Issue Date	Rev	Description	Drawn	Checked
15/09/2016	A	ISSUED FOR DEVELOPMENT APPLICATION	DVI	LT
07/02/2017	B	DEFERRED COMMENCEMENT - DA AMENDMENTS	DVI	LT
13/03/2017	C	SECTION 96 - LIGHTWELL	DVI	LT
24/05/2019	D	SECTION 96	DVI	LT
APRIL 2020	F	REVISED SECTION 96	DVI	LT

PROJECT	
GARLING HOUSE PROPOSED NEW RESIDENCE 24 LANCASTER CRESCENT, COLLAROY NSW LOT 3 DP.11899	
FOR MR & MRS GARLING

DRAWING TITLE	
PLANS SITE PLAN	
SCALE 1:200, 1:100 @ A2	DRAWN BY LT/DVI
PROJECT NO. 1612	PLOT DATE 9/04/2020
	REVISION
	DA-01 F

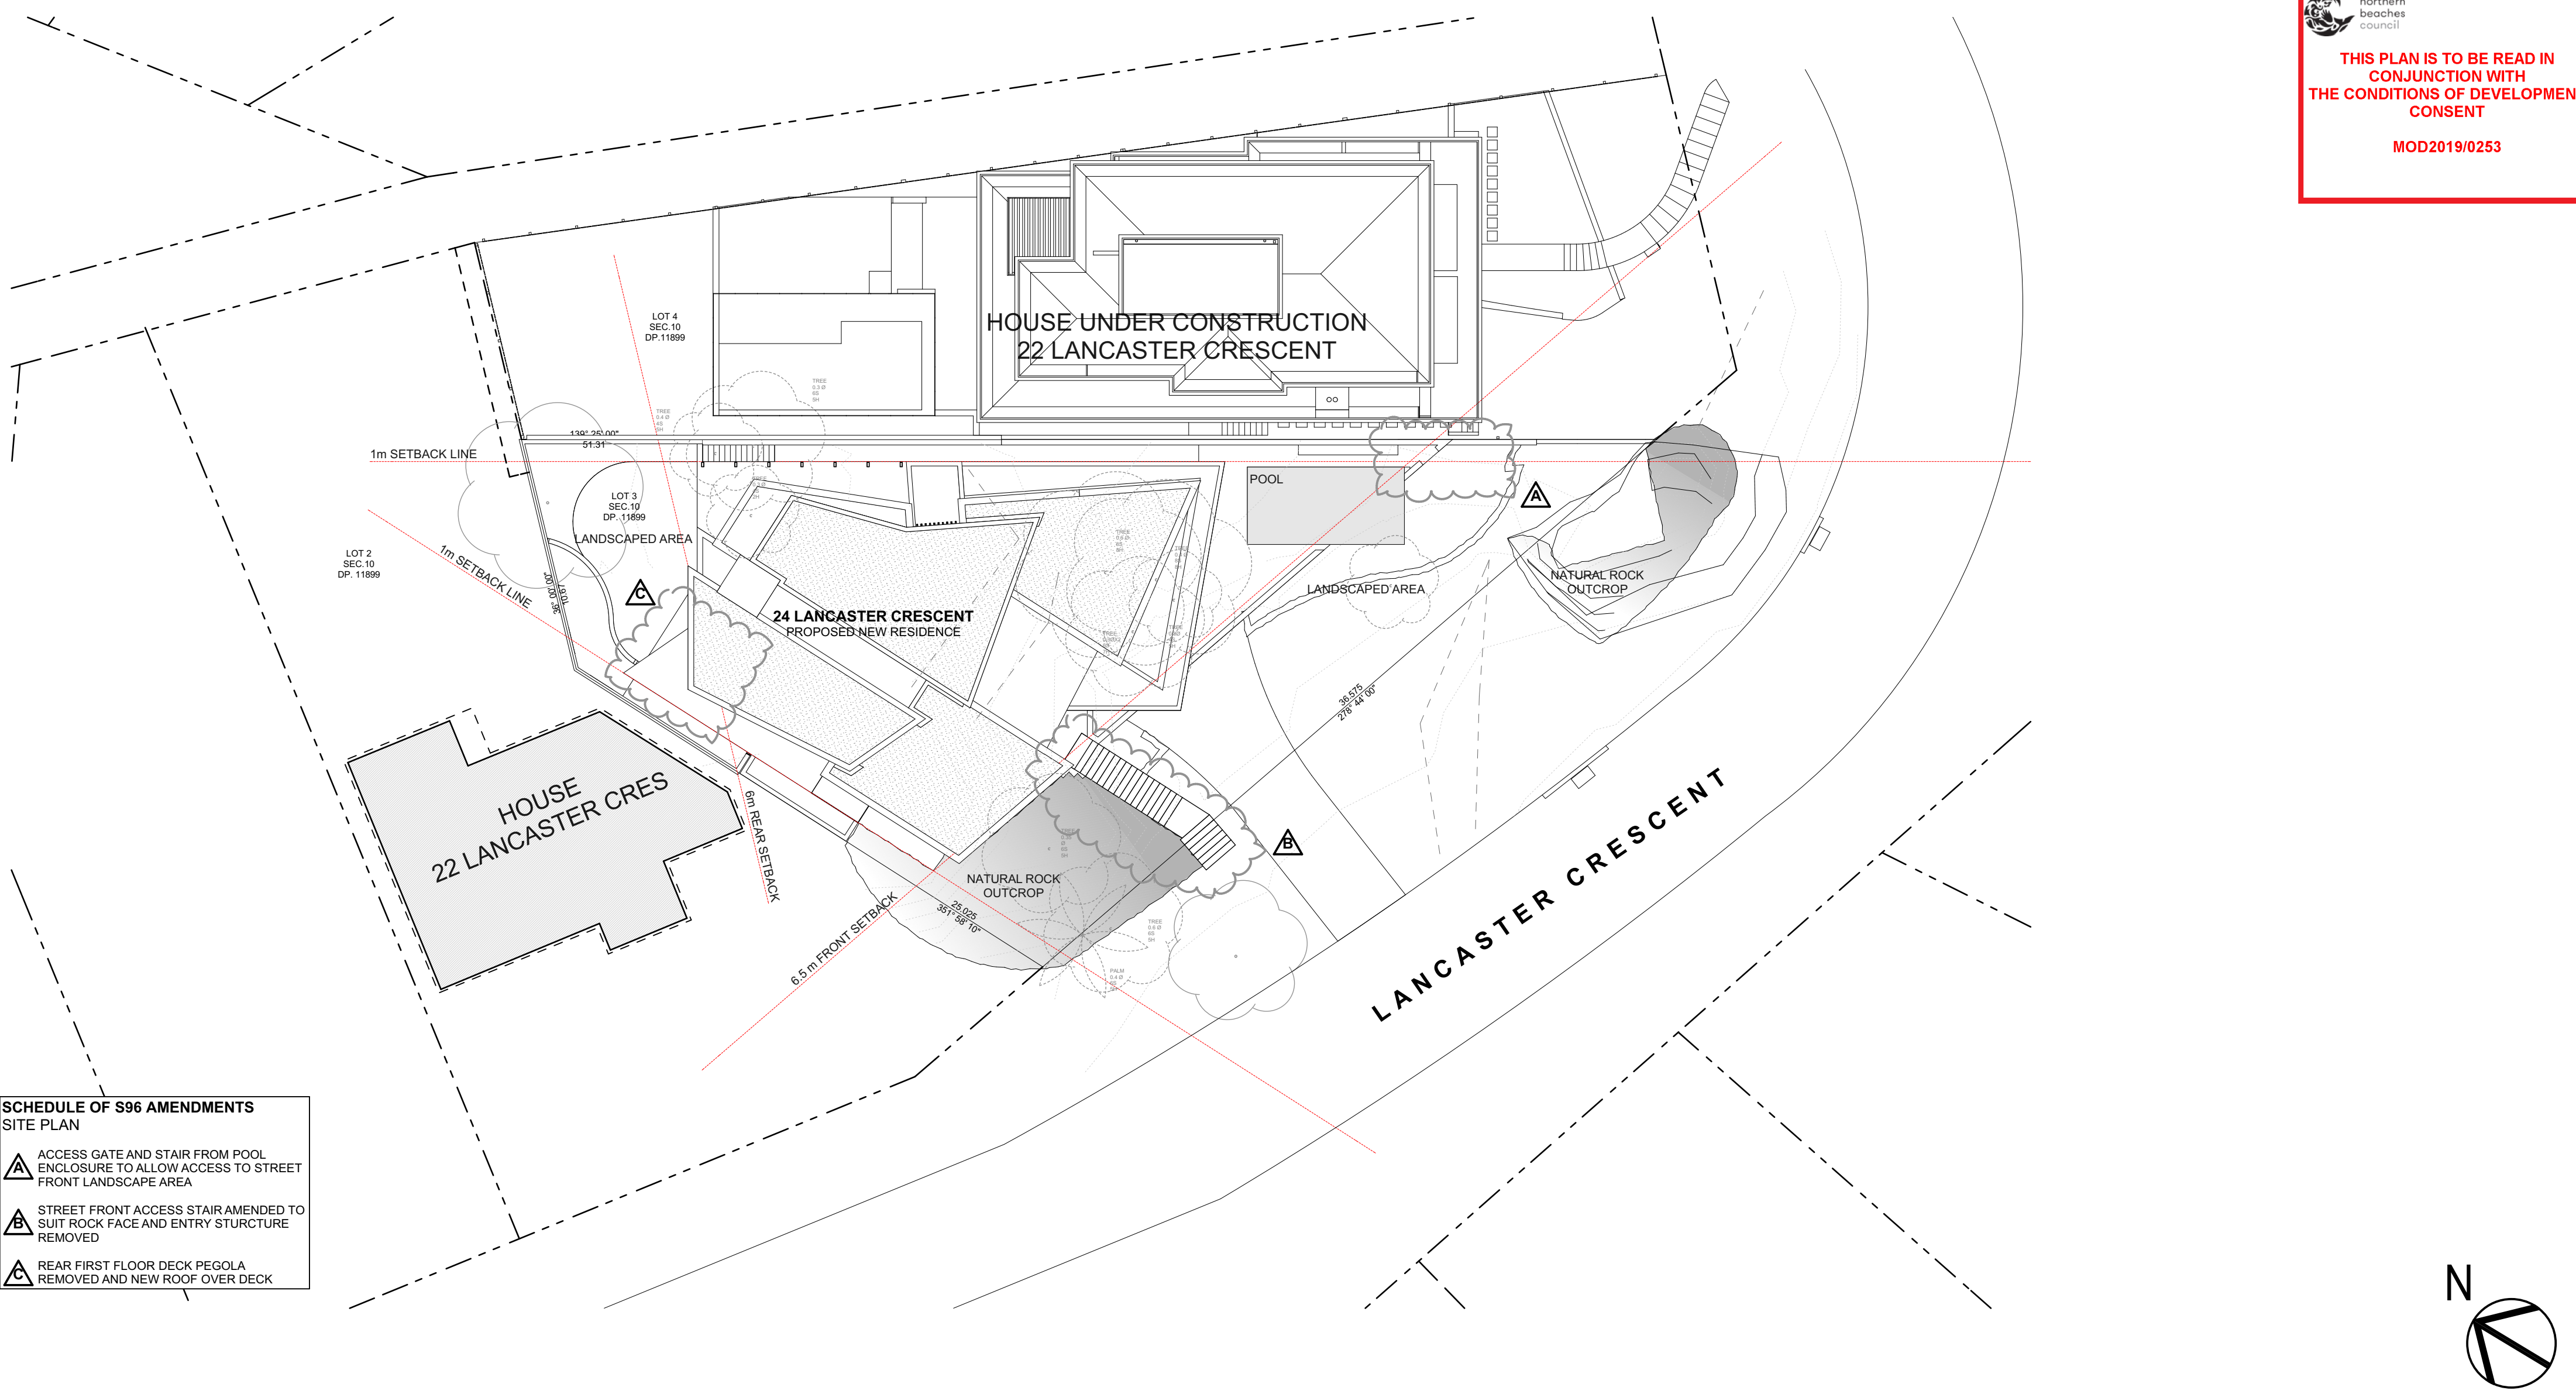
SCHEDULE OF S96 AMENDMENTS	
SITE PLAN	
	ACCESS GATE AND STAIR FROM POOL ENCLOSURE TO ALLOW ACCESS TO STREET FRONT LANDSCAPE AREA
	STREET FRONT ACCESS STAIR AMENDED TO SUIT ROCK FACE AND ENTRY STURCTURE REMOVED
	REAR FIRST FLOOR DECK PEGOLA REMOVED AND NEW ROOF OVER DECK

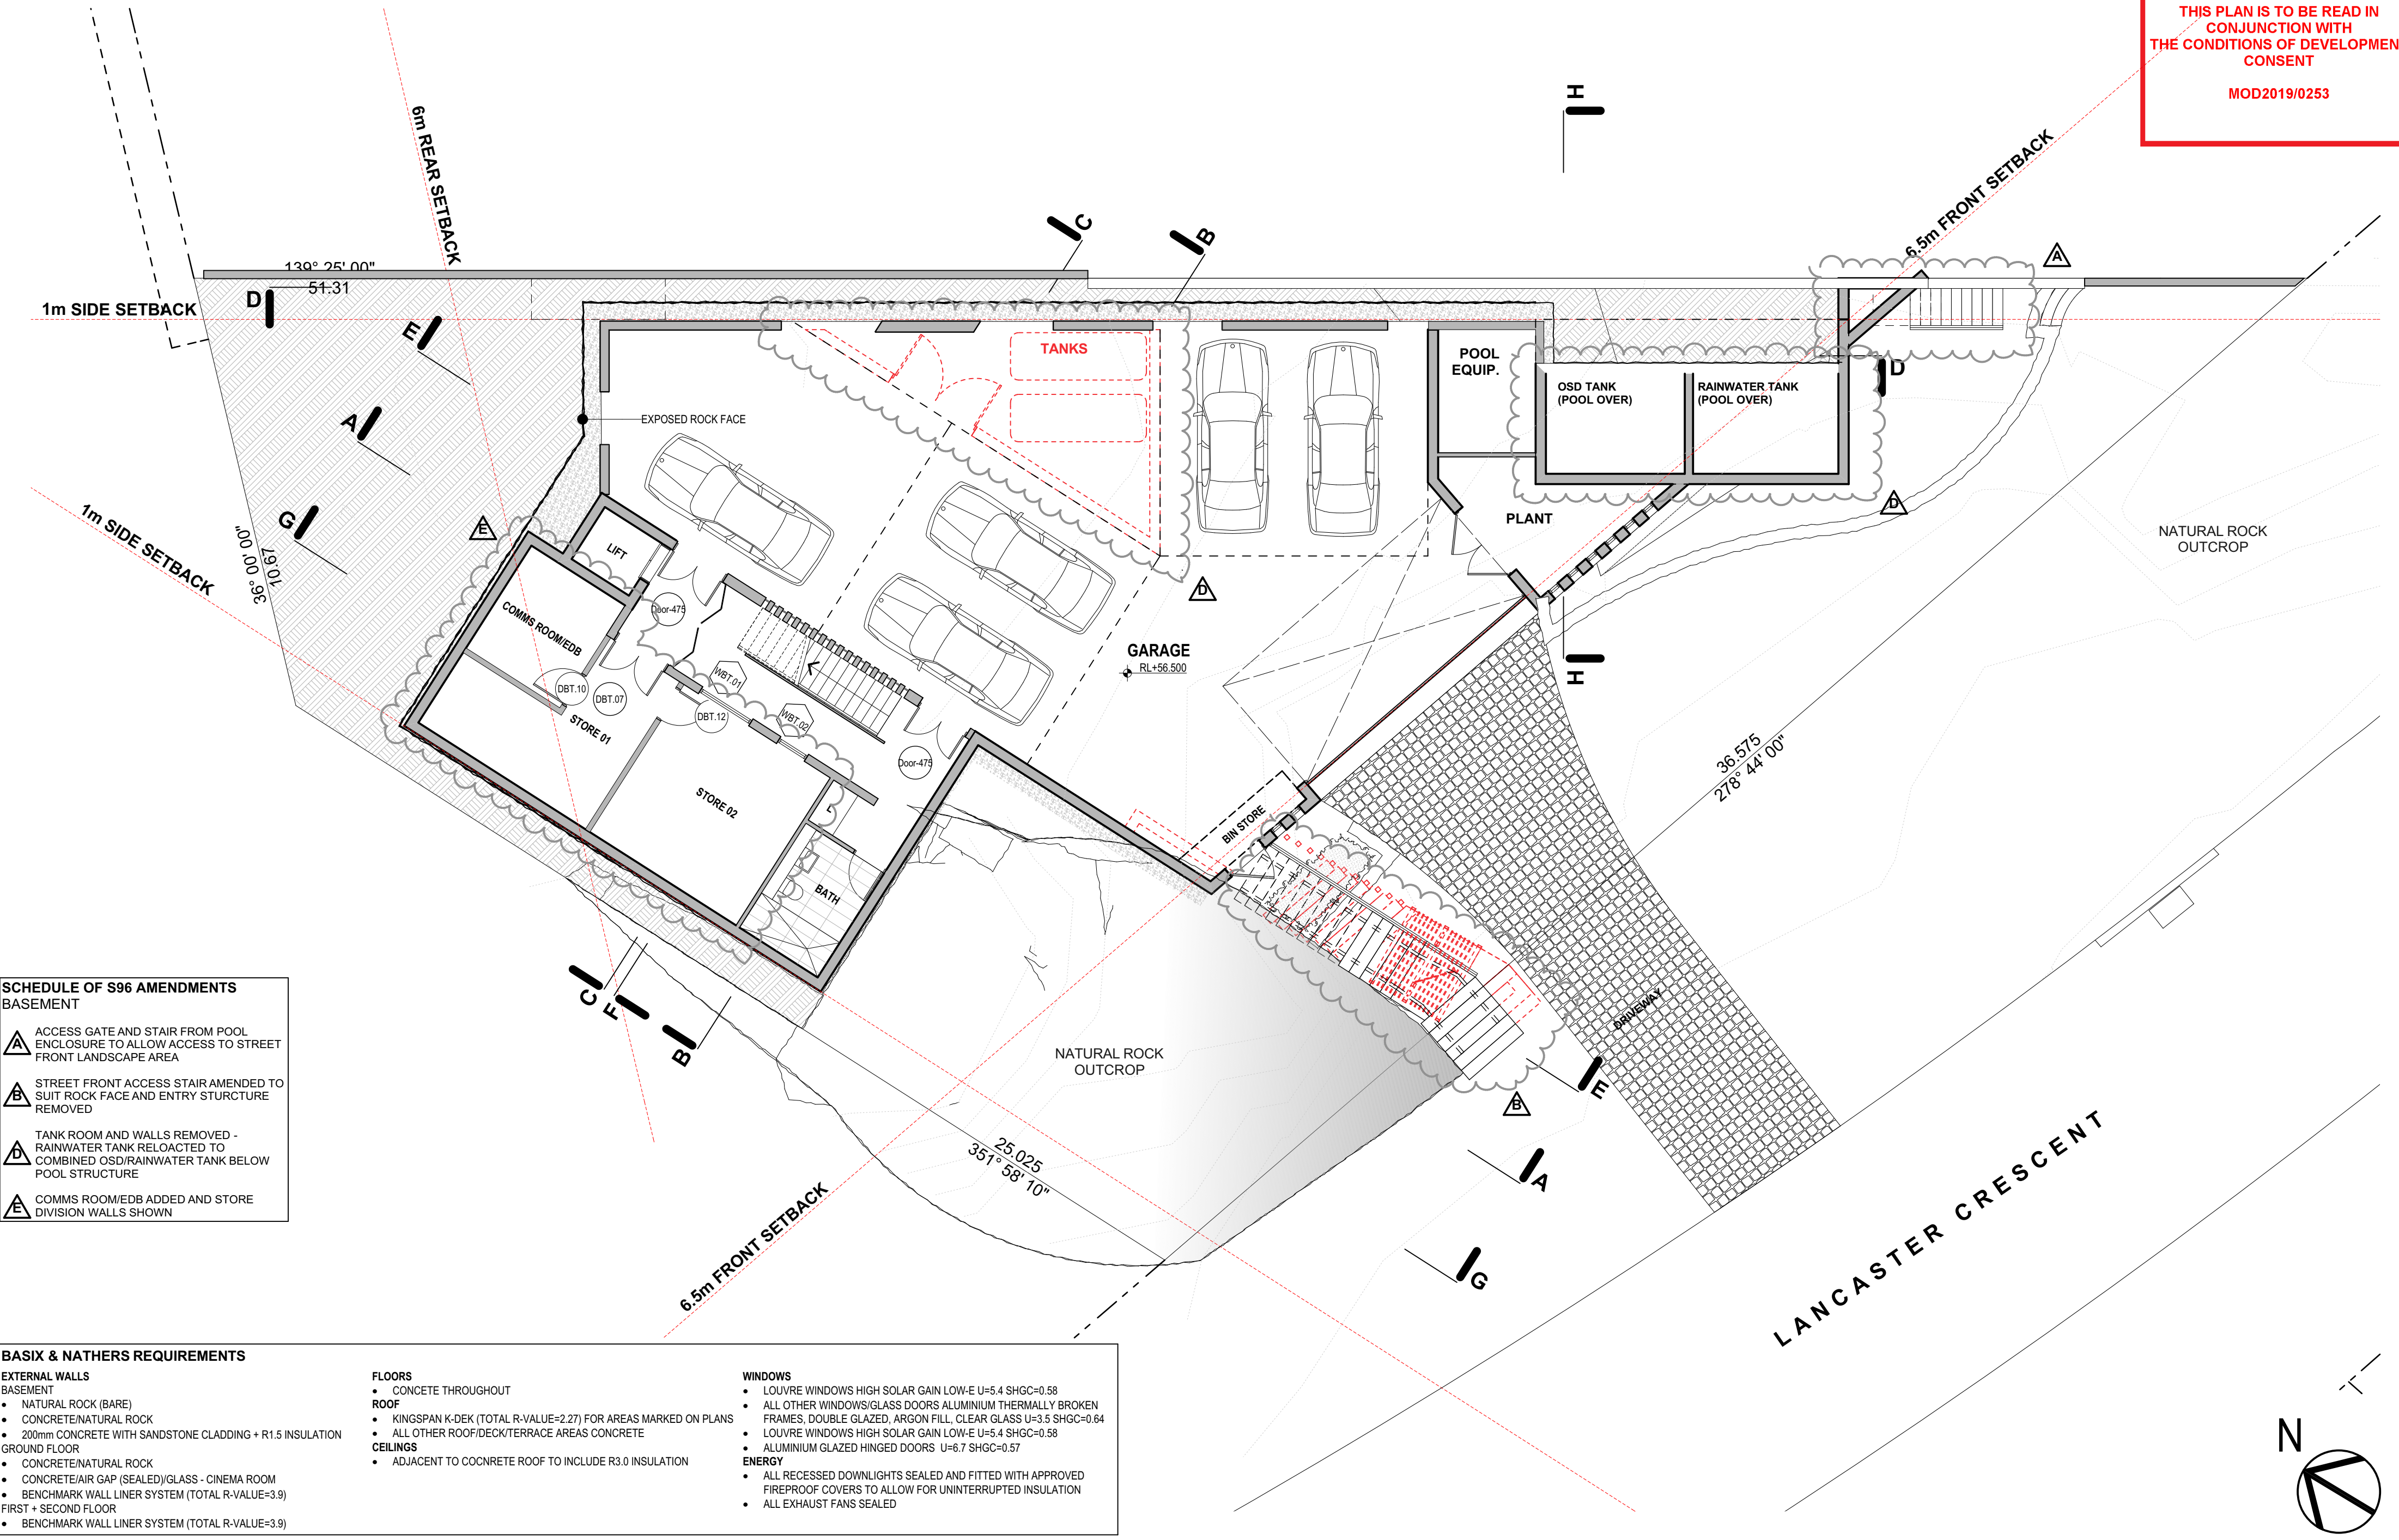
SCHEDULE OF S96 AMENDMENTS	
BASEMENT	
	ACCESS GATE AND STAIR FROM POOL ENCLOSURE TO ALLOW ACCESS TO STREET FRONT LANDSCAPE AREA
	STREET FRONT ACCESS STAIR AMENDED TO SUIT ROCK FACE AND ENTRY STURCTURE REMOVED
	TANK ROOM AND WALLS REMOVED - RAINWATER TANK RELOACTED TO COMBINED OSD/RAINWATER TANK BELOW POOL STRUCTURE
	COMMS ROOM/EDB ADDED AND STORE DIVISION WALLS SHOWN

DRAWING TITLE	
PLANS	
GROUND FLOOR	
SCALE	DRAWN BY
1:100 @ A2	LT/DVI
PROJECT NO.	REVISION
1612	DA-04
PLOT DATE	
9/04/2020	
	F

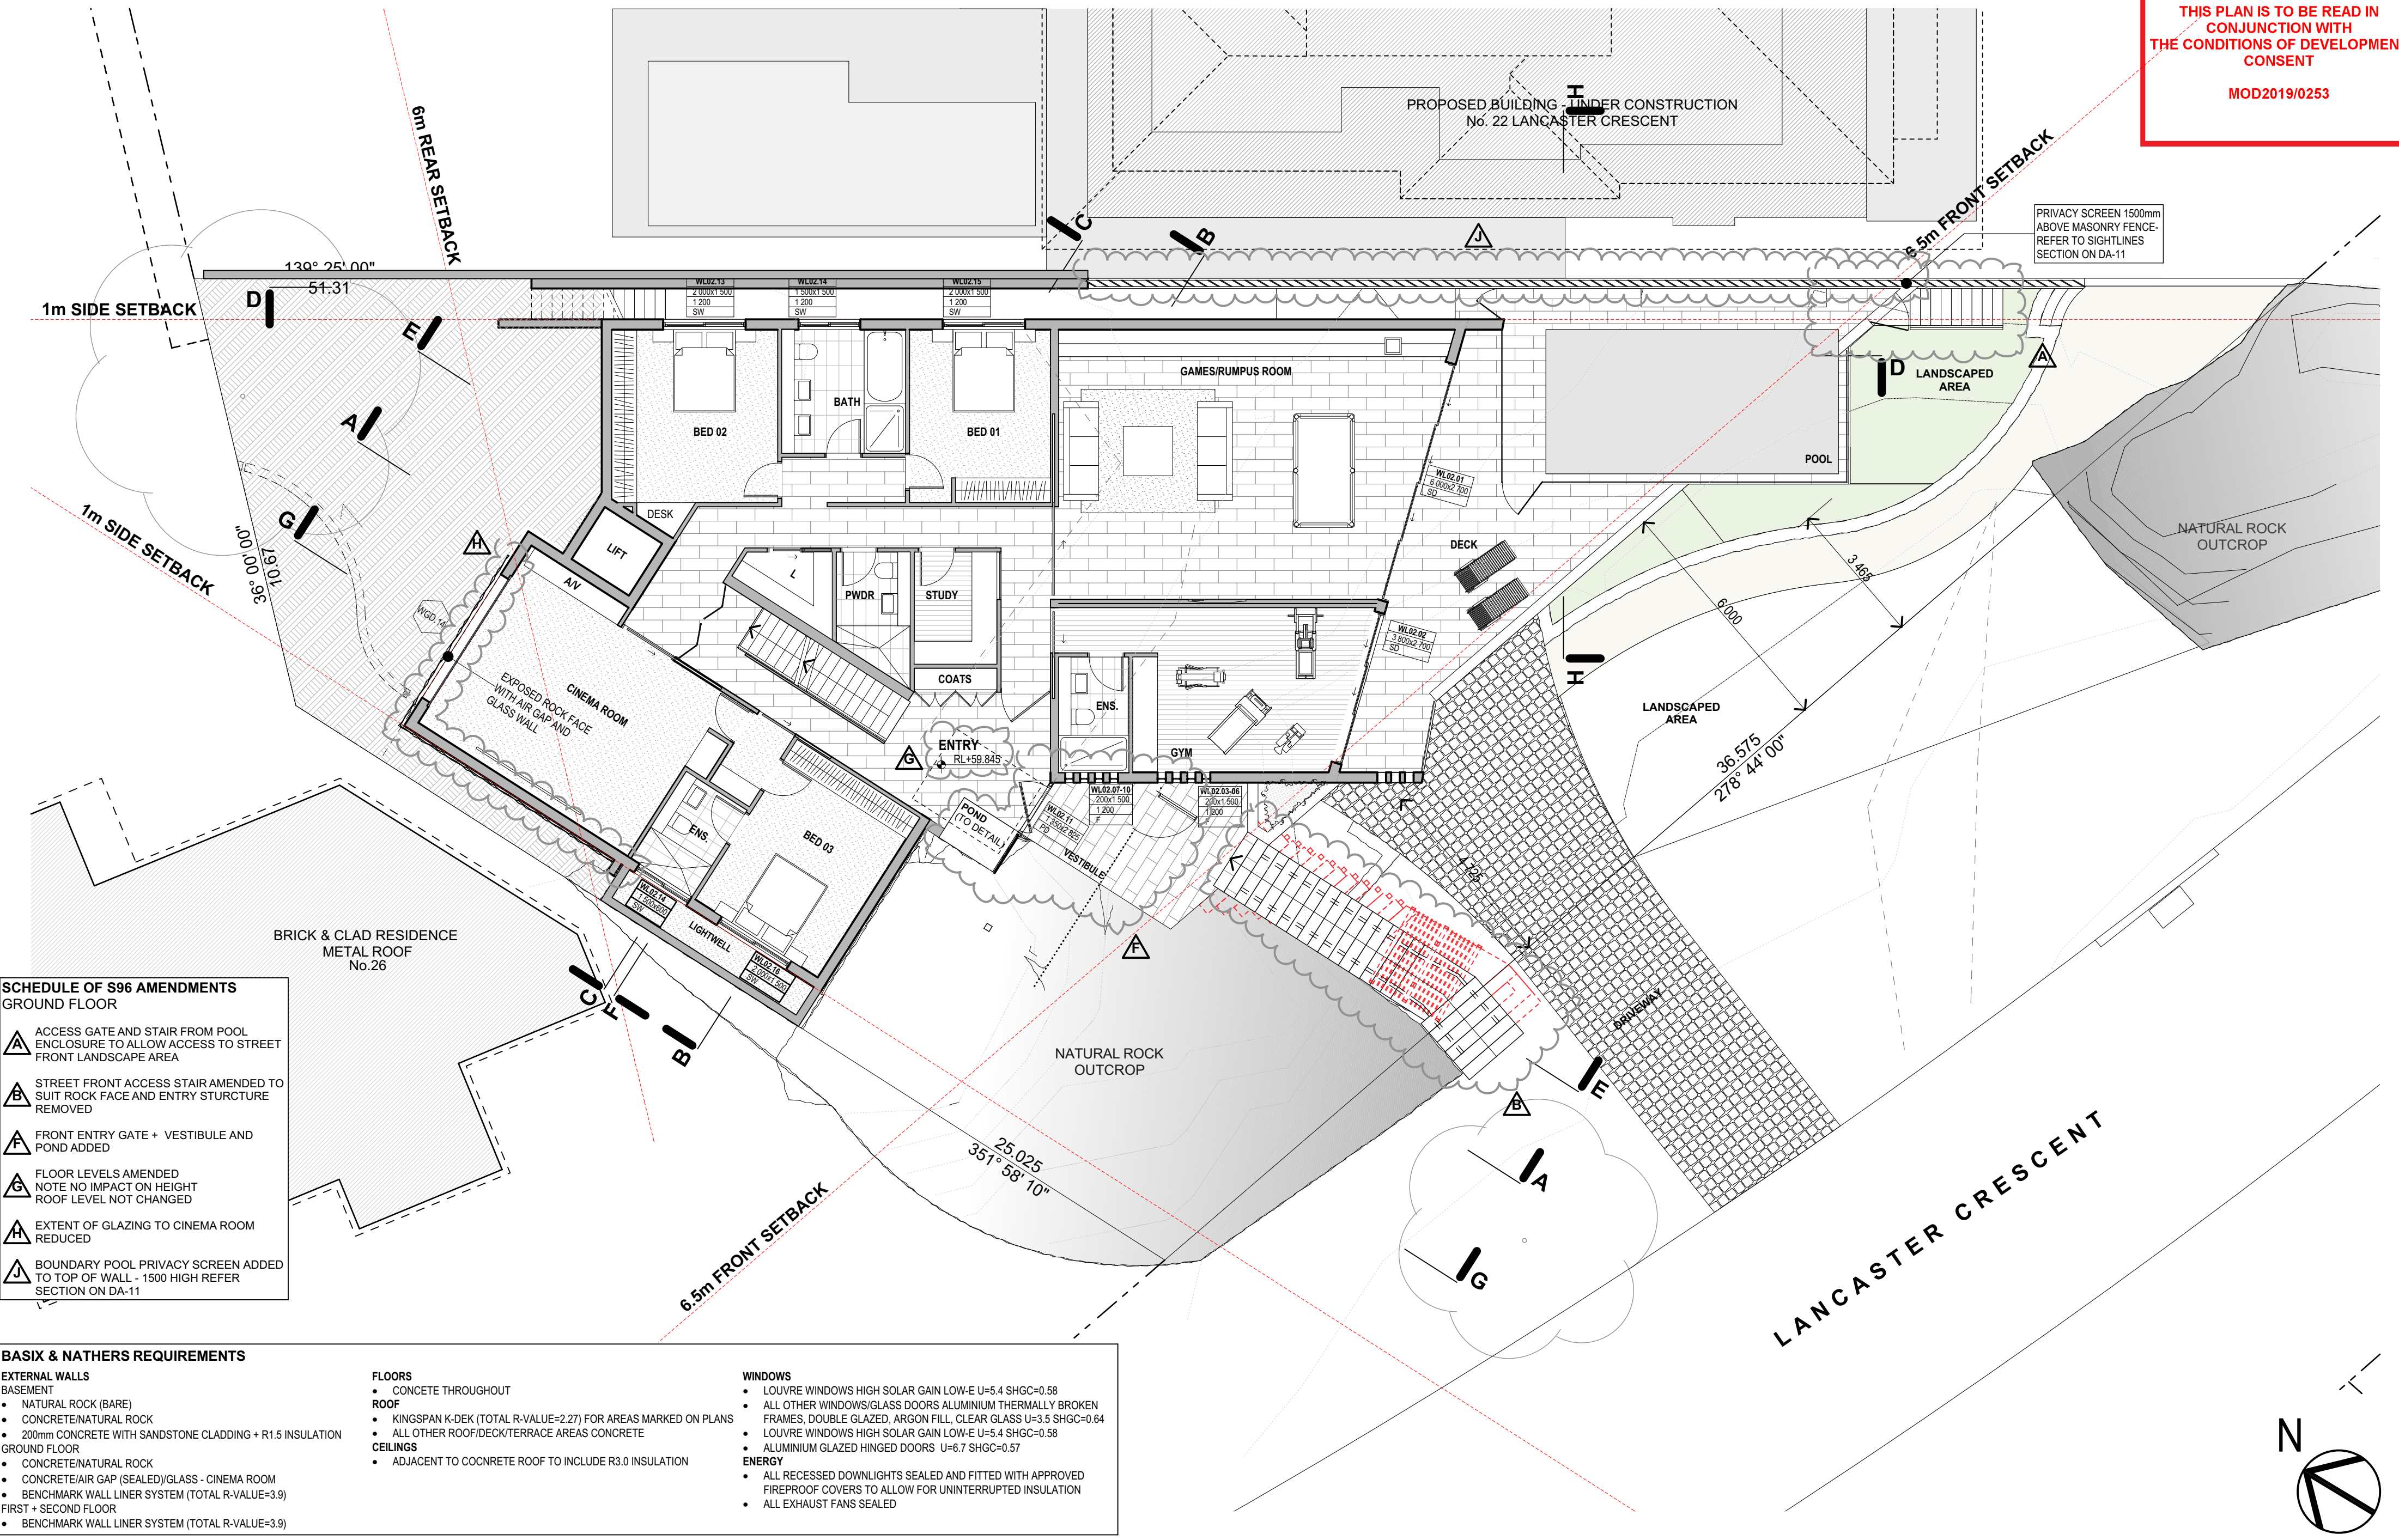
SCHEDULE OF S96 AMENDMENTS GROUND FLOOR	
	ACCESS GATE AND STAIR FROM POOL ENCLOSURE TO ALLOW ACCESS TO STREET FRONT LANDSCAPE AREA
	STREET FRONT ACCESS STAIR AMENDED TO SUIT ROCK FACE AND ENTRY STURCTURE REMOVED
	FRONT ENTRY GATE + VESTIBULE AND POND ADDED
	FLOOR LEVELS AMENDED NOTE NO IMPACT ON HEIGHT ROOF LEVEL NOT CHANGED
	EXTENT OF GLAZING TO CINEMA ROOM REDUCED
	BOUNDARY POOL PRIVACY SCREEN ADDED TO TOP OF WALL - 1500 HIGH REFER SECTION ON DA-11
